An Bord Pleanála,
64 Marlborough St.
Rotunda,
Dublin 1.

RE : Dart + West+ Project . Reference 314232 . Interested Party not notified and excluded from process.

My Name is Patrick Comerford and I wish lodge an objection and make observations in relation to the planning application submitted by Dart + West for planning permission for new Railway lines and Depot located between Maynooth & Kilcock. The project in its current form (your application reference 314232) is unacceptable and the application is invalid in so far as it has failed to adhere to the most basic planning regulation and furthermore I want to formally make a request for an Oral hearing.

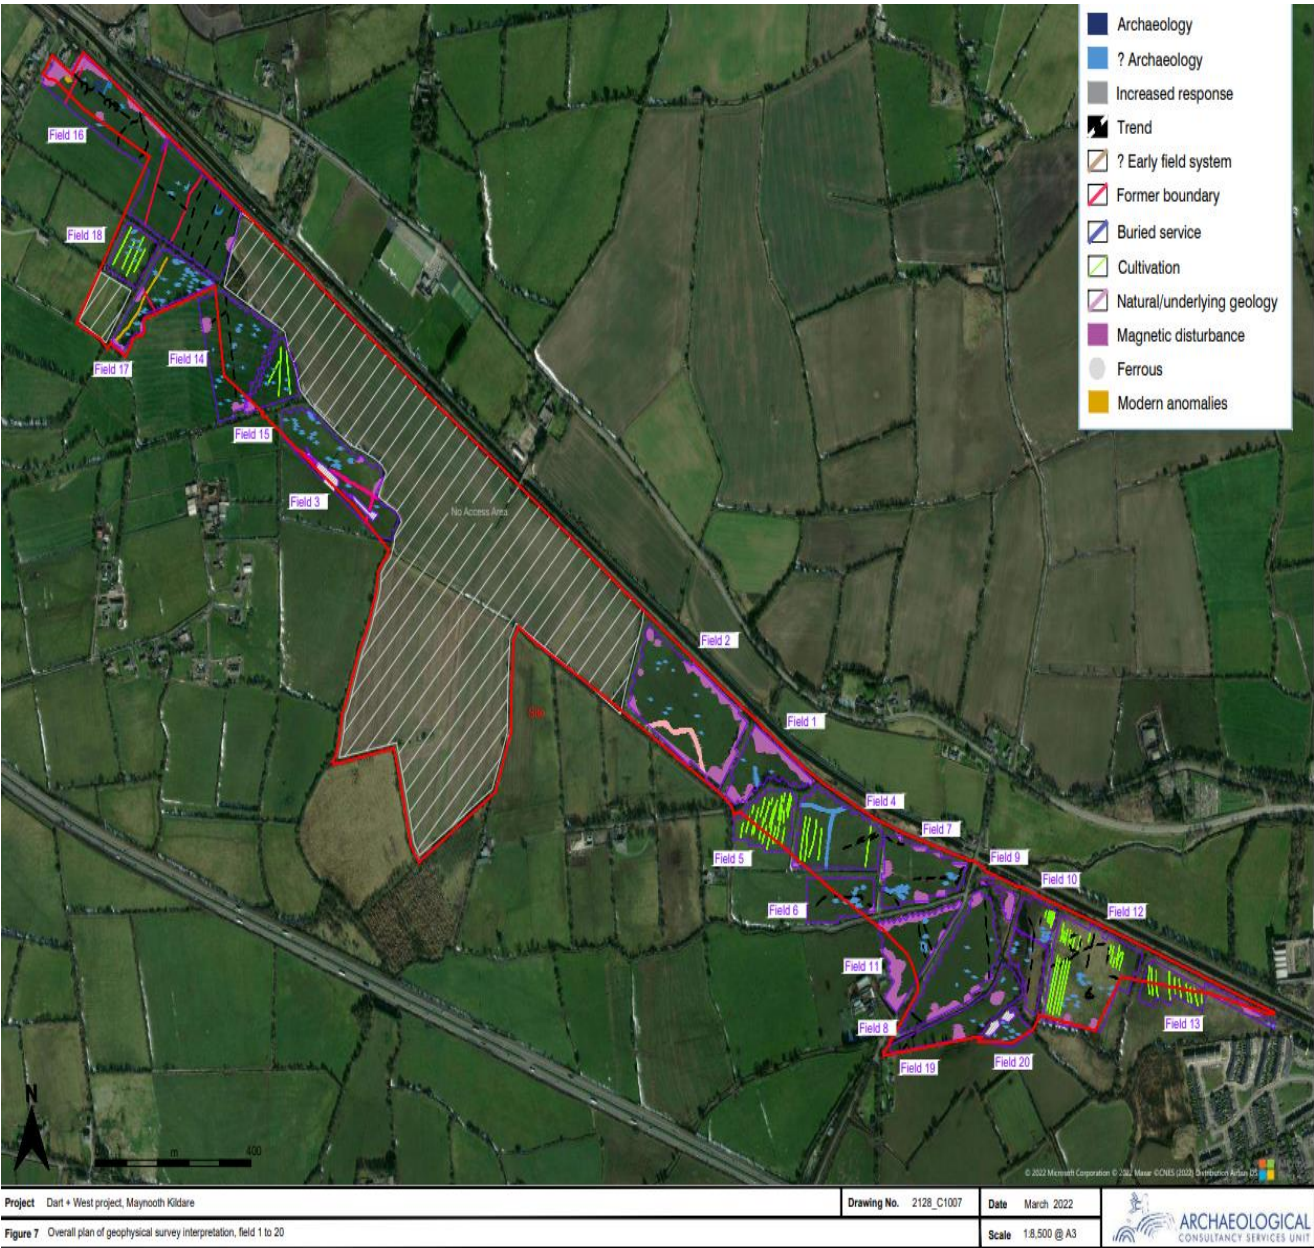
This plan shows the significant area around the depot which has not been investigated at all quoting reason for saying has no access.

Here we can clearly see almost 100 acres of the proposed site has not been inspected or investigated

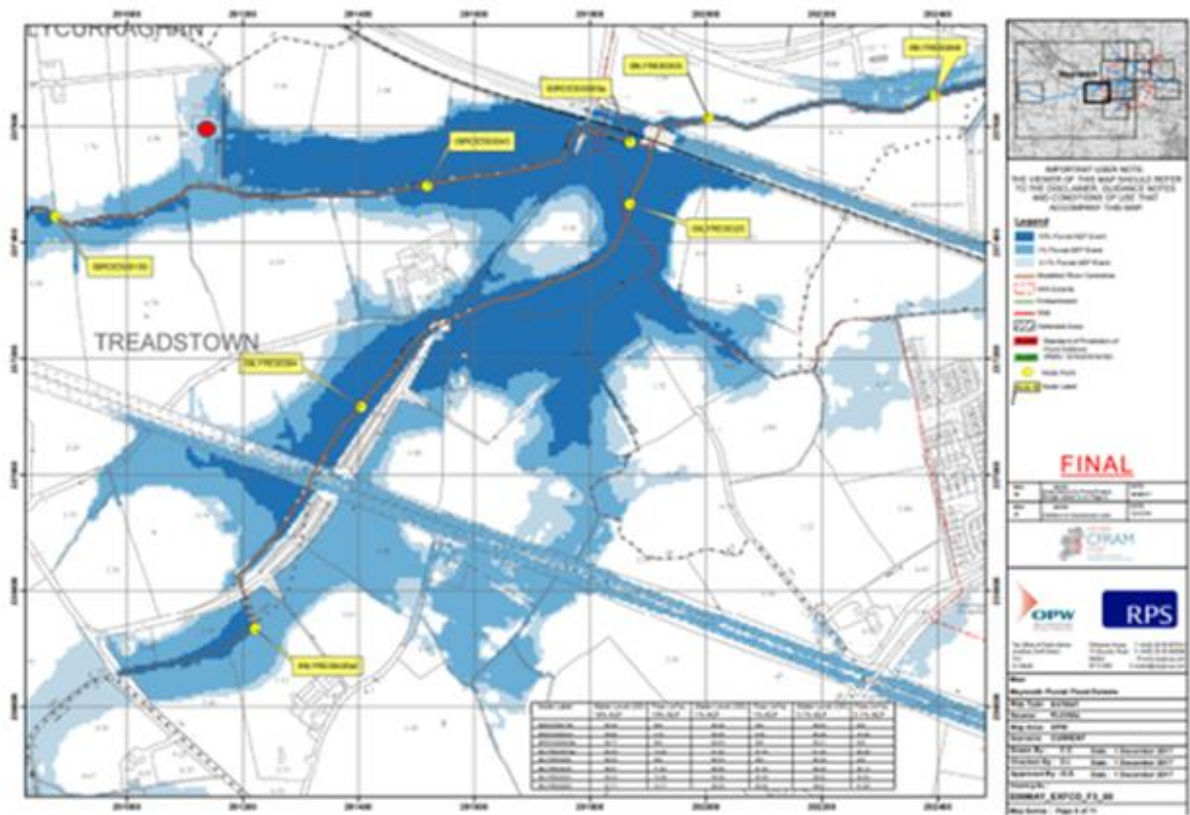
The Flood Management Guidelines firstly states that no development should occur within Flood Zone A which is represented on the OWP modelled flood map for this area by the medium blue colour extents.i.e. the 100 year event. The dark blue is the 1 in 10-year event and more frequent chance of occurring and the lighter blue the 1 in 1000-year event, less chance of occurring each year. I have shown the Gheel service site location with a red dot, currently inside the less frequent 1 in 1000-year event with the more frequent 1 in 100 year flood extent at its boundaries. Original pdf attached for clarity.

The flood management guidelines state that one should not build inside these flood areas because it will displace the flood water and change the shape of the flood. Now Irish Rail are proposing compensatory storage, which means the flood volume they are displacing can be catered for within specifically engineered locations as shown on Irish Rail map extract from their flood risk assessment below represented by green areas. However, upon review, it is clear that some of the proposed areas for compensation lie within existing flood zones and this is not good practice.

Picture of Junction for Ballycurraghan Road and Jacksons Bridge

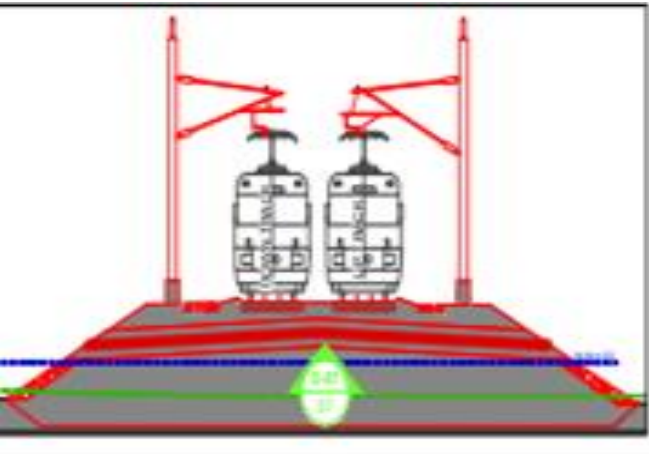
Levels at Jacksons Bridge and Train Levels Showing train line actual train level 1.4 m above flood plain average.

Blue line in picture above represents 60.36 which 1.40 above Ballycurraghan Lane level.
